**Re: Initial Submission Review: Parklands Coal Creek Infrastructure Site Plan (ISP)**  
**Application Number: DA-2289-05**  
**Case Number: 2024-6023-00**

## *Initial Submission Review*

# PARKLANDS COAL CREEK STRUCTURE SITE PLAN

PLAN & PROFILE STA. 94+00 - 108+00

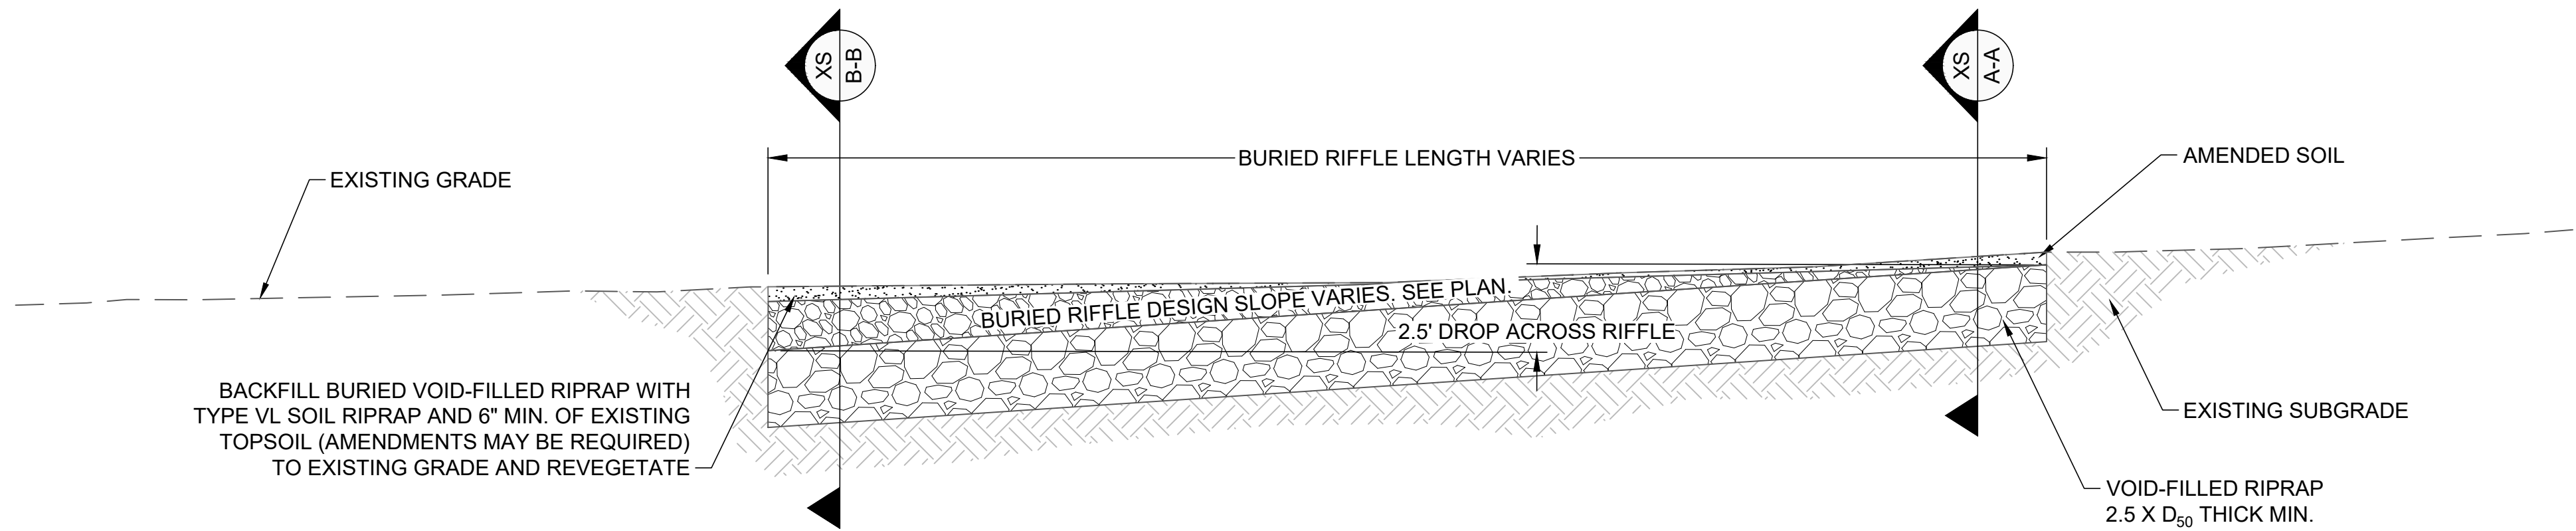
11E. Sheet 10 - The addition of a landscape plan to this plan set is warranted. The plan should address tree mitigation, seed mix, and other site restoration requirements to conform to PROS' needs since the property will be dedicated to the city for ownership and maintenance. Disturbed areas should be re-vegetated with a PROS-approved seed mix specified in the plan. Other PROS-approved plant materials should also be presented in a plant schedule for restoration purposes.

The addition of a landscape plan to this plan set is warranted. The plan should address tree mitigation, seed mix, and other site restoration requirements to conform to PROS' needs since the property will be dedicated to the city for ownership and maintenance.

Disturbed areas should be re-vegetated with a PROS approved seed mix specified in the plan. Other PROS approved plant material should also be presented in a plant schedule for restoration purposes.

**RESPONSE: MITIGATED TREES WILL BE PROVIDED IN FUTURE FILINGS ADJACENT TO COAL CREEK. A RE-VEGETATION PLAN HAS BEEN PROVIDED IN THE ISP.**

RESPONSE: A TREE MITIGATION PLAN WITH A TREE INVENTORY AND RE-VEGETATION PLAN HAVE BEEN ADDED TO THE ISP SHEETS
